FIELD INSPECTION

Project Name:	Mountain Valley Pipeline	Inspector:	Marshall Willis
Inspection Date:	Monday, December 2, 2019	Project Contact:	Brian Clauto, Cory Chalmers
Spread I: Franklin County	STA 14411+04 – 14546+75 MVP-FR-315	Weather (Wet/Dry/Rain):	Wet

FIELD INSPECTION PHOTO LOG

Fig. 1: **STA 14545+00** – Discharge bypassing CFS end-treatment. Maintenance needed.

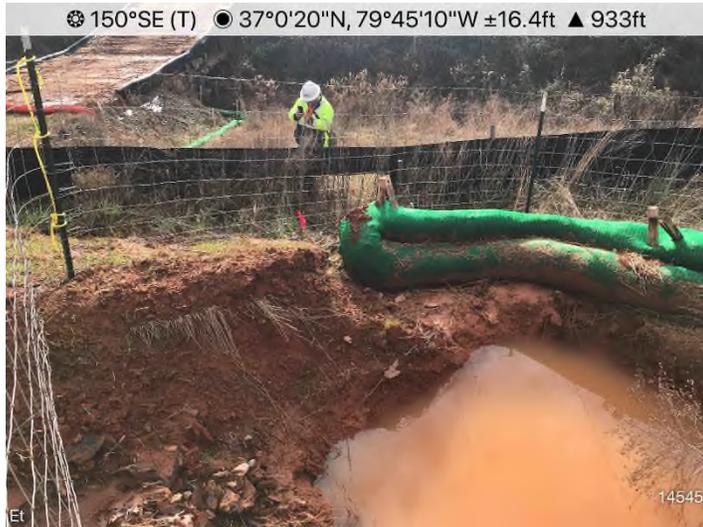
- STA 14545+00: End-treatment bypassed.
- STA 14510+00: CFS maintenance needed.
- STA 14504+50: Erosion matting needed on slope.
- STA 14486+00: Stabilize slope CIS Stream S-G22.

Recommended Corrective Action: Maintain and install all controls per the approved plans and PSS&S.
